*Re: Application of Dino and Michelle DeLaurentiis for Site Plan Approval for the
Construction of a Single-Family Residence and a Tree Removal Permit
To Permit Tree Removal in Connection with the Development of the Residence
Property: 21 Nethermont Ave. North Castle Tax Map Section 122.16, Block 4, Lot 41*

MEMORANDUM

SUBJECT: 21 Nethermont Ave

DATE: June 21, 2022

LINE OF SIGHT PROFILES BASED ON ACHIEVABLE STOPPING SIGHT DISTANCE

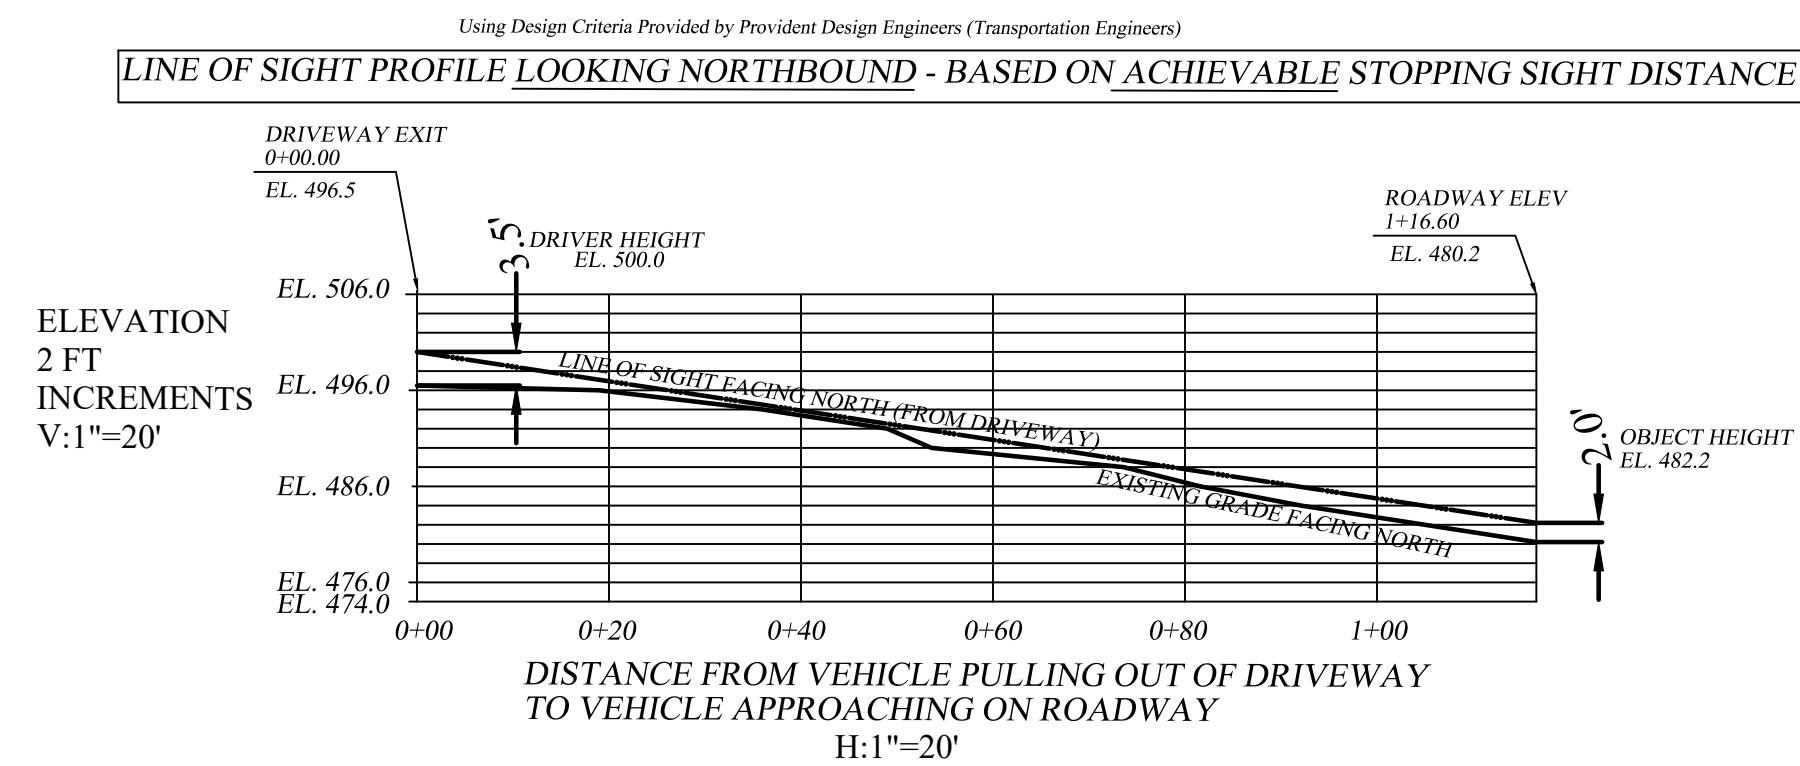
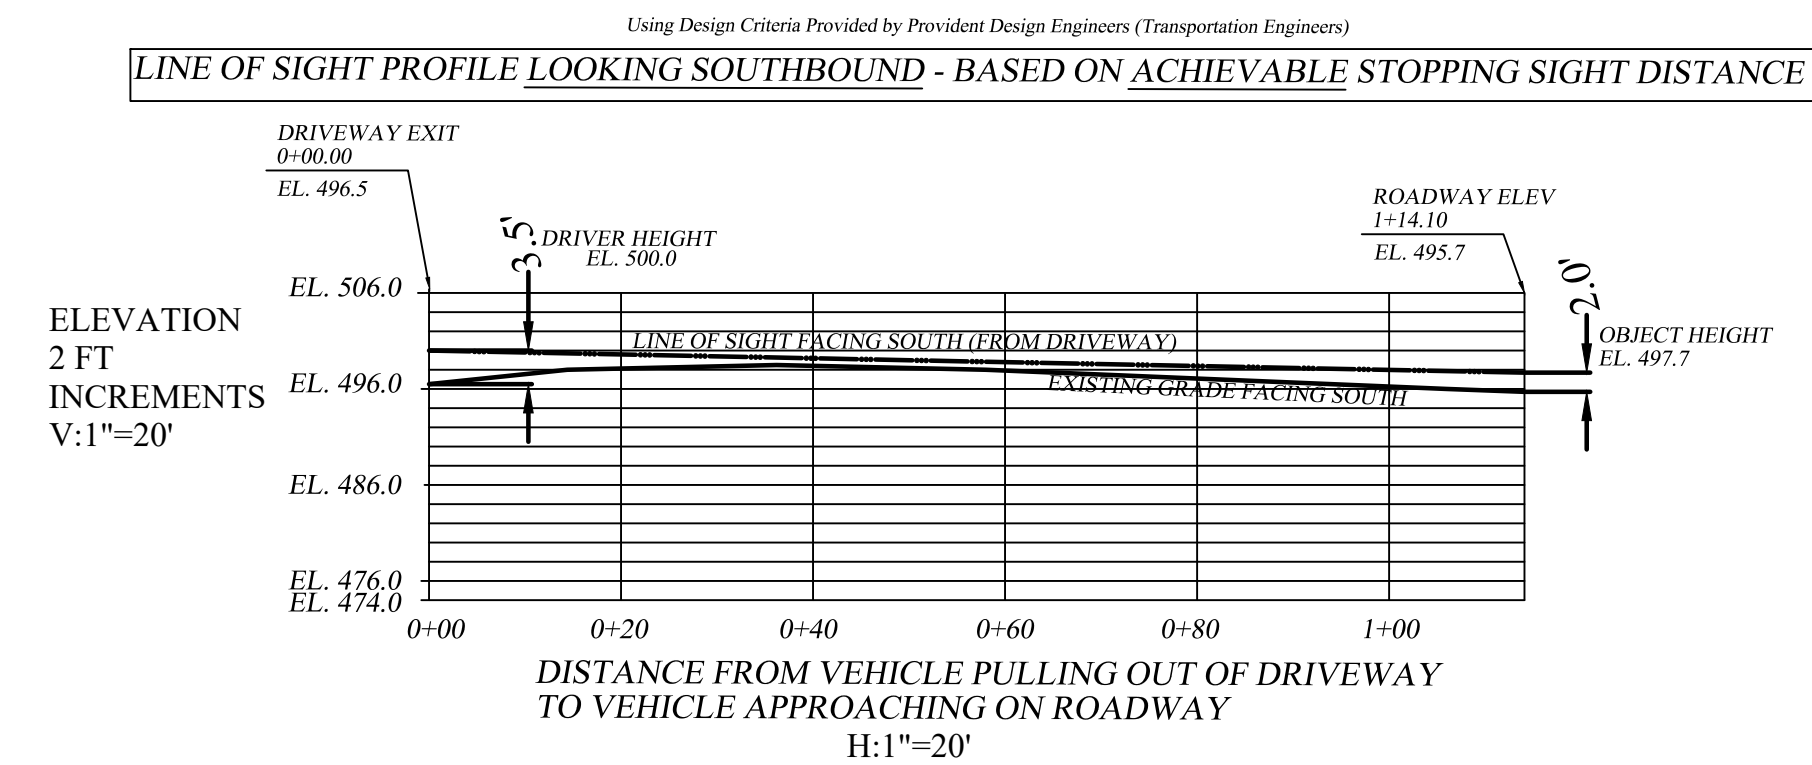
8. As previously requested, sight distance profiles have been provided, however, they shall be corrected to illustrate adequate sight distance for a minimum of 200 feet in each direction. It is difficult to verify compliance based on the imagery provided. We would suggest importing the GIS topography and planimetric data to generate the profile as opposed to working from an image. The sight profile shall establish the driver's eye set 3.5 feet above grade, 14 feet back from the edge of the road with a line of sight to an object in the road 2 feet above grade. The elevations shall use the same datum as the submitted plans and correspond to the grades in the profiles.

The sight analysis plans for either the original or alternative driveway access do not illustrate all information necessary to properly evaluate the alternatives. The topography used for the analysis does

not correspond to the proposed grading plan. It seems that rather than convert the Westchester County GIS data to the plan topography, the opposite was done. This should be corrected for consistency and coordination with the proposed plan. Neither alternative illustrates the dense vegetation that exists along the northern property line, much of which is on the adjoining property and not und

er the applicant's control. The alternative driveway plan notes that the sight lines are obscured to the north due to a minor conflict with the proposed driveway turnaround. It appears that this could be rectified as part of the proposed grading plan. Finally, both alternatives will require sight easements across the front yards of both neighboring properties. The applicant should update the Board regarding any conversations they may have had with the property owners, as well as any communication with the Town Highway Department regarding any required clearing in the Town right-of-way. If the minimum required sight distance cannot be obtained, the plan should illustrate the minimum that can be provided as an area variance would be required from the Zoning Board of Appeals.

A Zoning Variance was obtained for the sight distance.

PLANTING PLAN
 Application No.: 2020-2947
 21 Nethermont Avenue
 White Plains, New York 10603
 Tax ID: 122.16-4-41
 Zoning District: R-5
 REVISED: 6/10/22
 May 4, 2022
 Sheet: 2 of 2

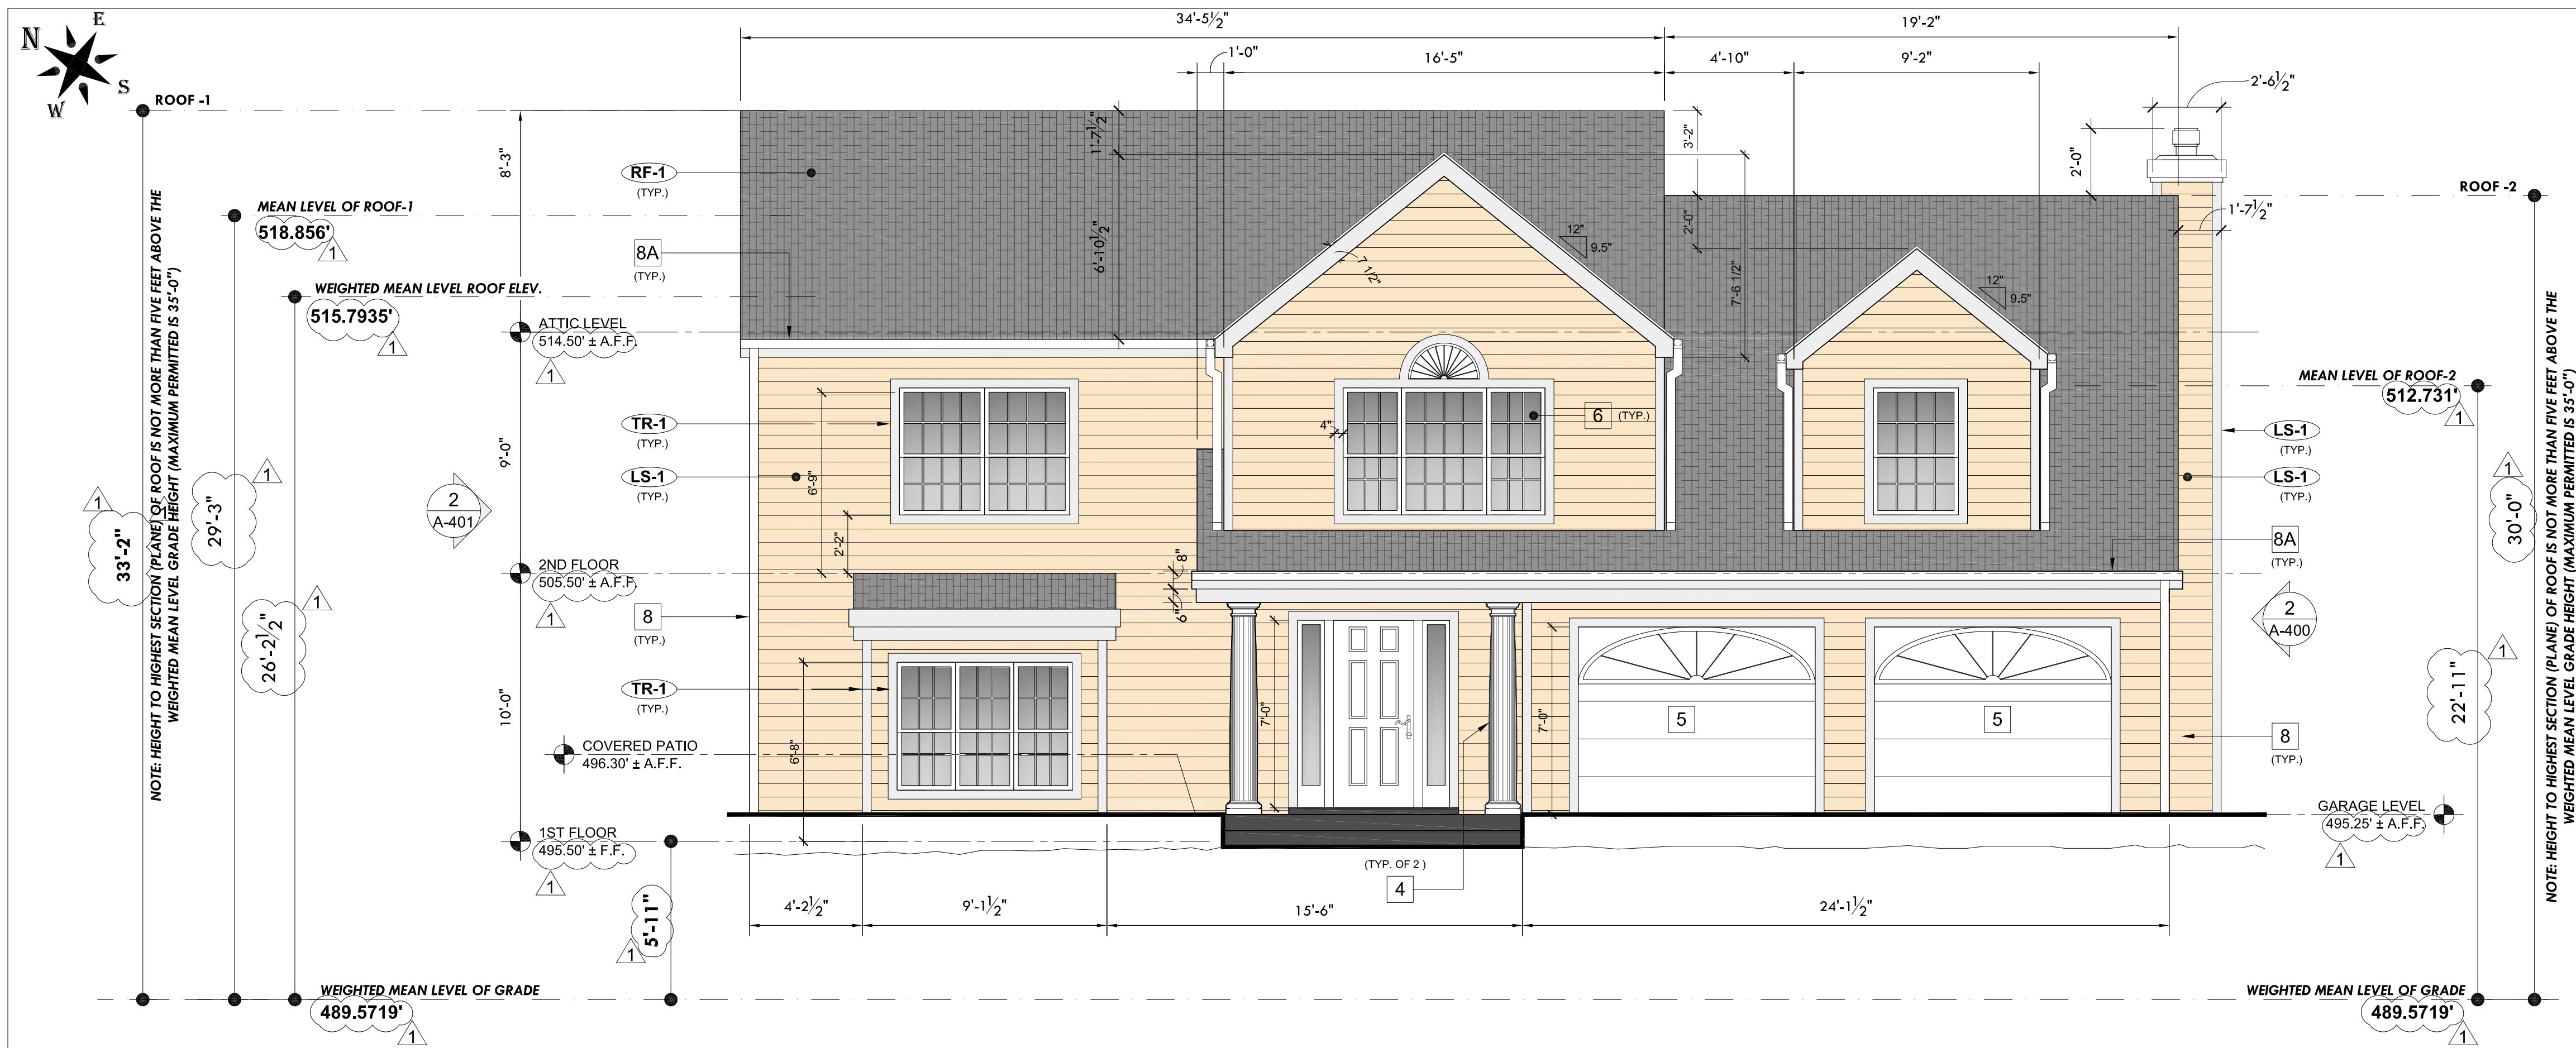
10. As previously noted, a Landscaping Plan has been referenced but not submitted. The applicant shall submit a Landscape Plan and Restoration Plan, in accordance with Section 308.15.A(11) of the Town Code. The plan shall include a planting schedule that includes common name, scientific name, label symbol, size and quantity of proposed plants. The requested Landscape Plan shall be provided and coordinated with the final plan layout.

A Landscape Plan has been provided
